STATE OF FLORIDA  
DEPARTMENT OF HEALTH  
ONSITE SEWAGE TREATMENT AND DISPOSAL  
SYSTEM  
APPLICATION FOR CONSTRUCTION PERMIT

CONSTRUCTION PERMIT FOR: OSTDS Repair  
APPLICANT: (Alachua County Housing Authority Lot 15)  
PROPERTY ADDRESS: 14236 SW 170th St Archer, FL 32618  
LOT: 15 BLOCK: 4 SUBDIVISION: Thistle Hills West  
PROPERTY ID #: 05081-015-000 [SECTION, TOWNSHIP, RANGE, PARCEL NUMBER]  
[OR TAX ID NUMBER]

**From:** Harris, Todd S  
**Sent:** Thursday, May 31, 2018 1:20 PM  
**To:** 'flsepticsolutions@yahoo.com'  
**Subject:** 5-314-18 Lot 15 THW

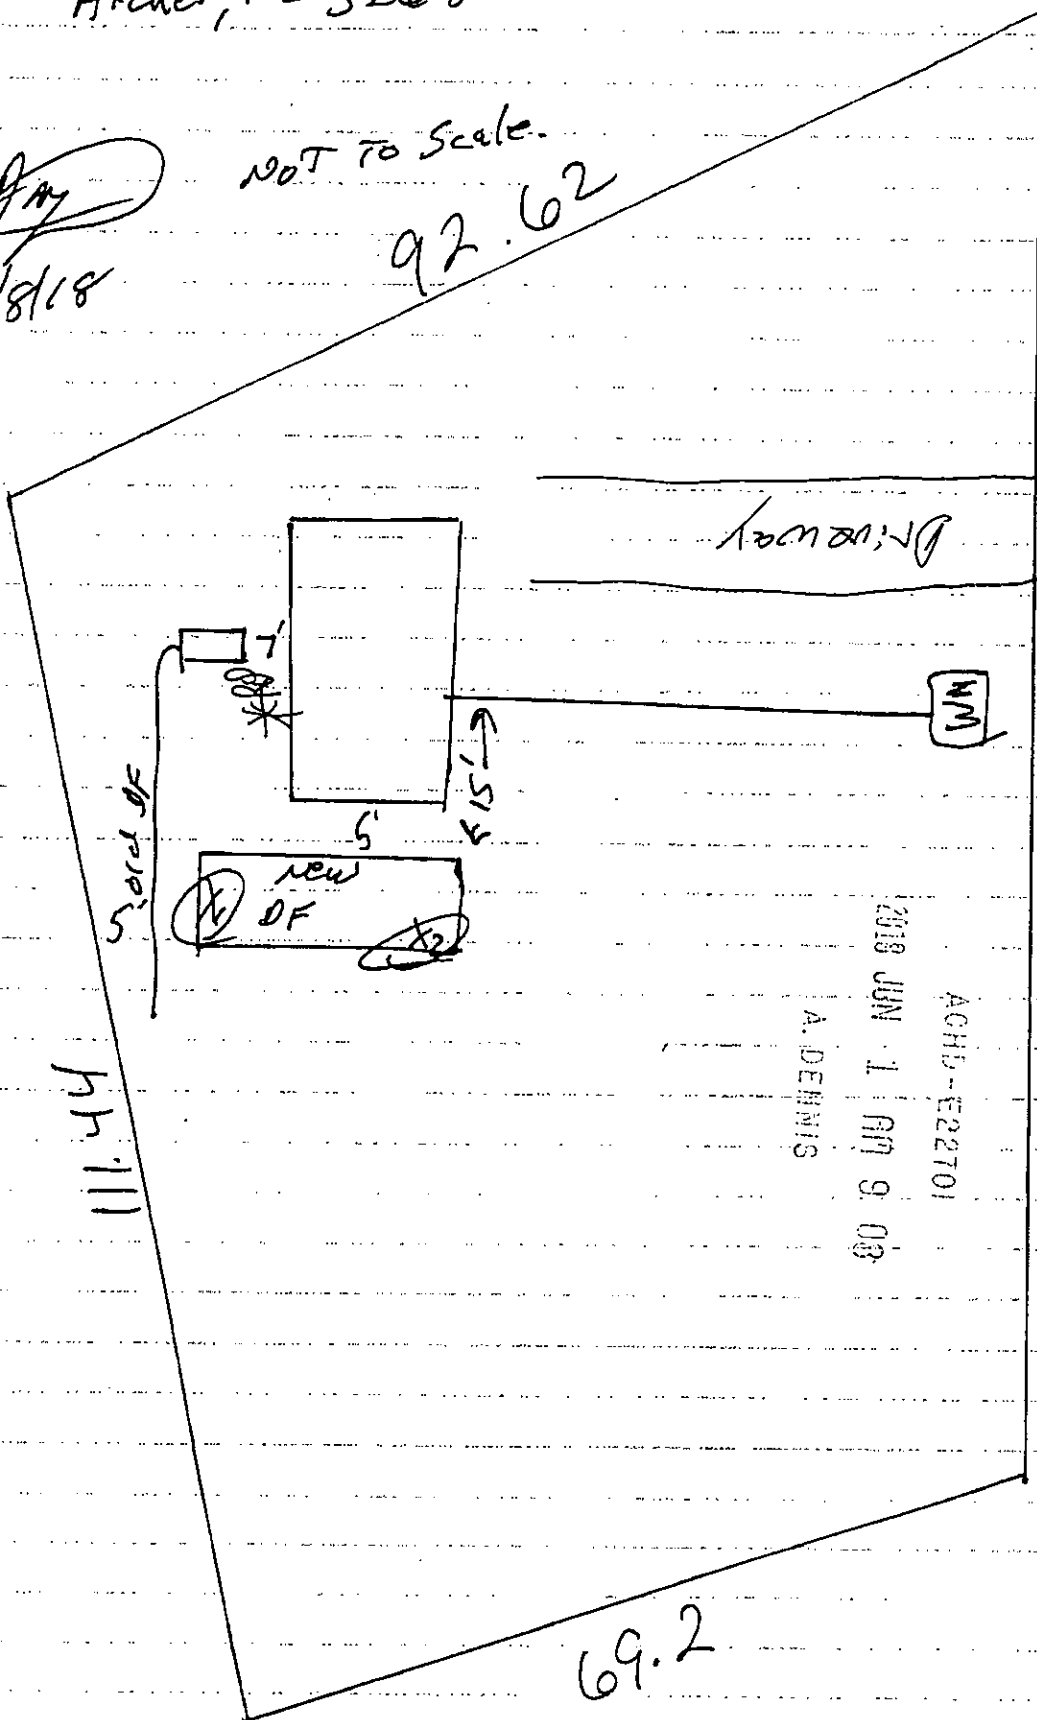
1. Driveway / parking needed on site plan
2. BM location needed on site plan
3. Only one soil profile provided
